Engineering Services for Waste to Energy

Client: M/s Jakob Stiefel Technik AG

Project: KR - SLM

Water and Steam System Clarification

P&ID of Water and Steam System

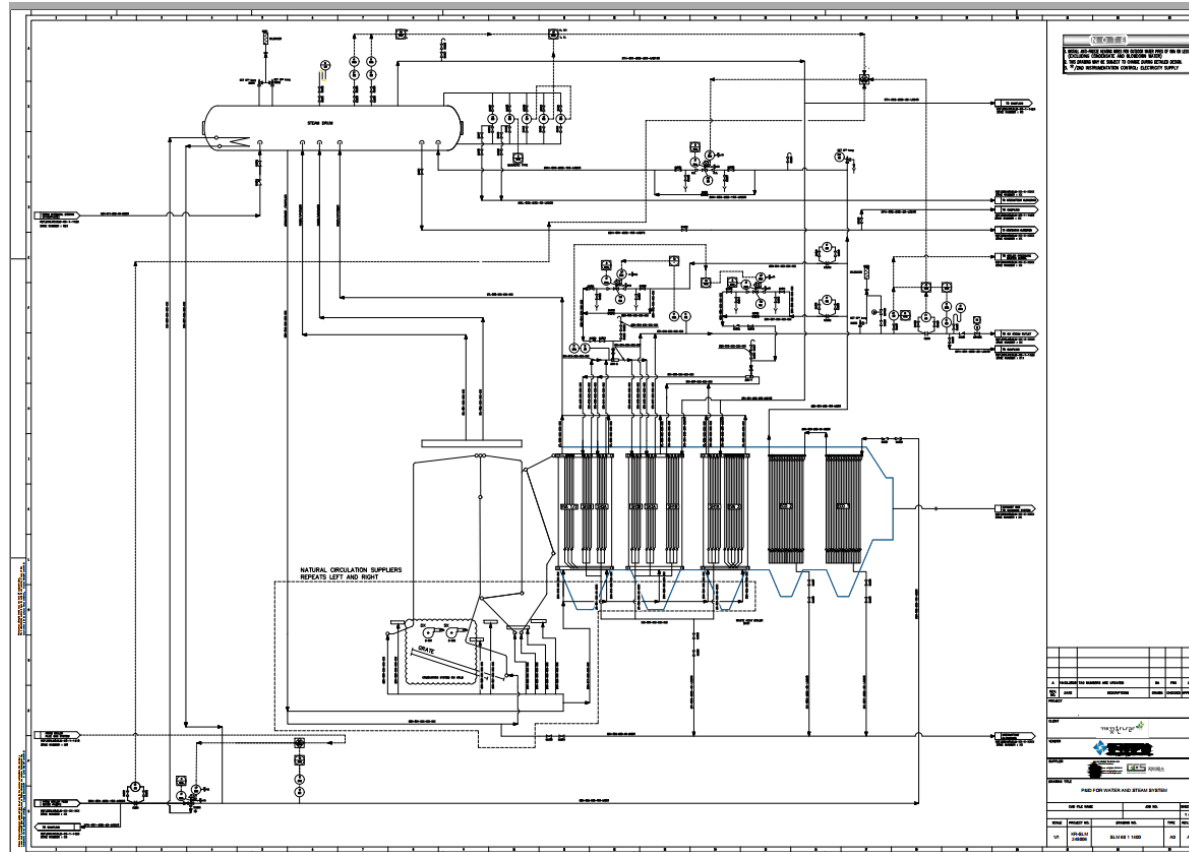
| Sl. No | PID Name | PID Zone Number | AESPL Clarification Dated 19 Feb 2025 |
|--------|--------------------------------|-----------------------|--|
| 1 | PID for Water and Steam System | Q2, D8 | <p>We kept the pipe line designation details as in the new PID. If not available, the pipe line designation details are shown as "XXX-XX-XXX".</p> <p>BWH-801-B3B-100-LR850 BWH-831-XXX-XXX-XXX</p> |
| 2 | PID for Water and Steam System | Q1 | <p>kindly provide the Boiler Feed Water (BFw) terminal point details for new this PID. We will update the same in PID instead of XXXX</p>  |
| 3 | PID for Water and Steam System | G20 (full steam line) | <p>For system number for steam, there is no specific number is mentioned. Hence, we followed the system number 9 which mentioned as "Other system"</p>  |
| 4 | PID for Water and Steam System | P20 and D20 | <p>kindly provide the intermittent blowdown tank terminal point details for new this PID. We will update the same in PID instead of XXXX</p>  |
| 5 | PID for Water and Steam System | E20 | <p>kindly provide the intermittent exhaust gas to cleaning system terminal point details for new this PID. We will update the same in PID instead of XXXX</p>  |
| 6 | PID for Water and Steam System | E20 | <p>kindly provide the boiler pressure master signal terminal point details for new this PID. We will update the same in PID instead of XXX</p>  |
| 7 | PID for Water and Steam System | E20 | <p>kindly provide the continuous blowdown terminal point details for new this PID. We will update the same in PID instead of XXX</p>  |
| 8 | PID for Water and Steam System | D2 | <p>For system number for chemical dosing system, there is no specific number is mentioned. Hence, we followed the system number 9 which mentioned as "Other system"</p> <p>CDH-911-B3B-40-LR850</p> |
| 9 | PID for Water and Steam System | A21 | <p>In PID notes, we have followed as per the reference PID. Please advise if any additional notes are required or provided notes</p> <div style="border: 1px solid black; padding: 5px;"> <p>NOTE</p> <ol style="list-style-type: none"> 1. INSTALL ANTI-FREEZE HEATING WIRES FOR OUTDOOR WATER PIPES OF 50A OR LESS (EXCLUDING CONDENSATE AND BLOWDOWN WATER) 2. THIS DRAWING MAY BE SUBJECT TO CHANGE DURING DETAILED DESIGN. 3. * /2ND INSTRUMENTATION CONTROL: ELECTRICITY SUPPLY </div> |
